RE: ENERGY STAR for Doors, Windows and Skylights Specification Version 6.0 Draft 1 Feedback

This letter contains ProVia's response to ENERGY STAR's proposed Product Specification for Residential Windows, Doors, and Skylights, Draft 1 Version 6.0. Thank you for the opportunity to provide feedback concerning the proposed criteria prior to implementation. ProVia's comments and questions for clarification are below by section.

Figure 1. Visible light spectral properties for double and triple silver coat low-e glass.

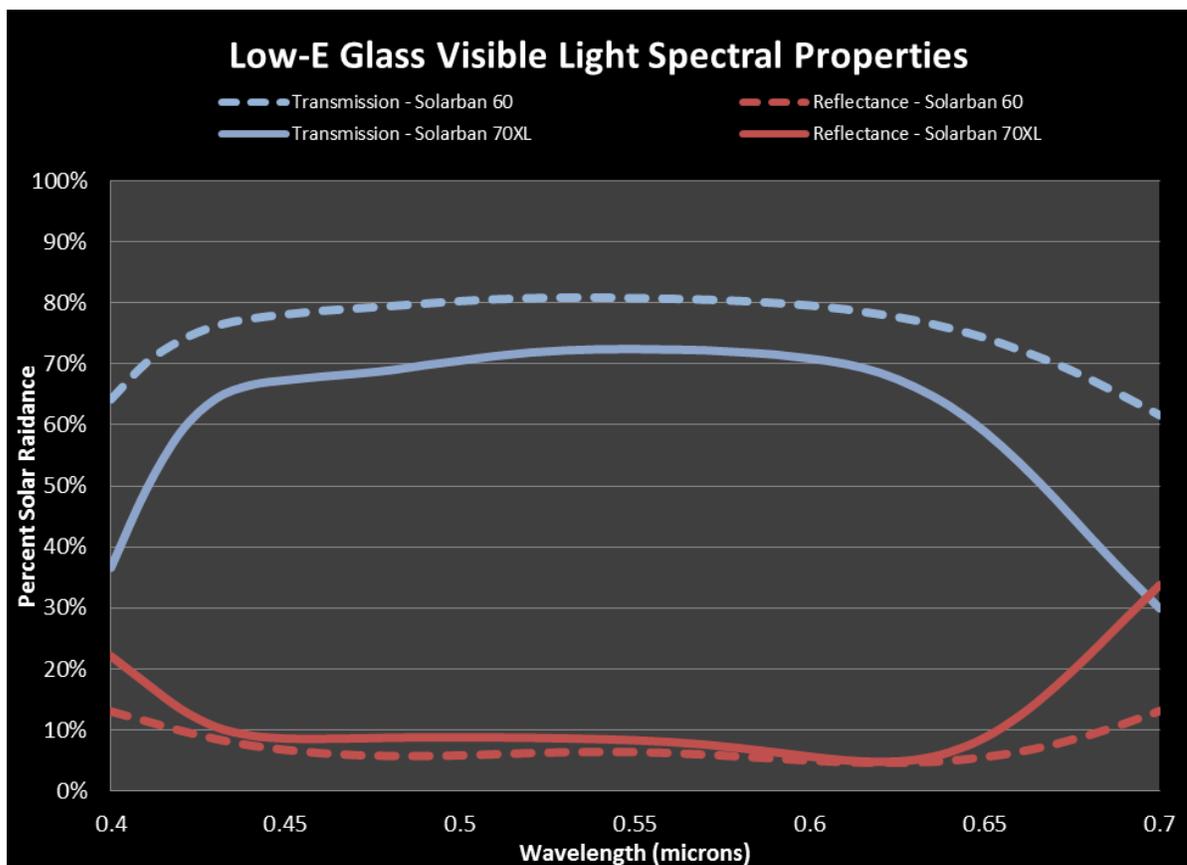
Low SHGC doors in Northern climate zones also create a visual appearance problem. To meet the SHGC requirement glazed doors must use a triple silver low-e glass in northern climates. Windows, having no SHGC requirement in the north, typically use a double silver low-e glass. When placed on the same wall the triple silver low-e glass is noticeably darker and more reflective than the double silver low-e glass.

ProVia compared the optical properties of PPG’s double and triple silver low-e coated glass using Lawrence Berkley National Laboratory’s (LBNL) Optics 5 and Window 6 software. The center of glass visible transmittance and front of glass reflection for PPG’s double silver low-e, Solarban 60, is 0.80 and 0.06 respectively. PPG’s triple silver, Solarban 70XL, low-e has a visible transmittance of 0.71 and front of glass reflection of 0.08, yielding an 11% reduction in visible light transmittance and a 33% increase in visible reflectance. The Optics 5 spectrum analysis shown in Figure 1 illustrates the differences in visible light transmission, color and reflectance between the two glass types. Glass samples have been mailed to D&R International attention Emily Zachery for your physical review.

The door SHGC requirement must be properly balanced between the Southern and Northern climate zones considering doors use a one size fits all approach for the SHGC criteria. ProVia recommends setting the door SHGC requirement at 0.30, or splitting the SHGC requirement for doors into two climate zones.
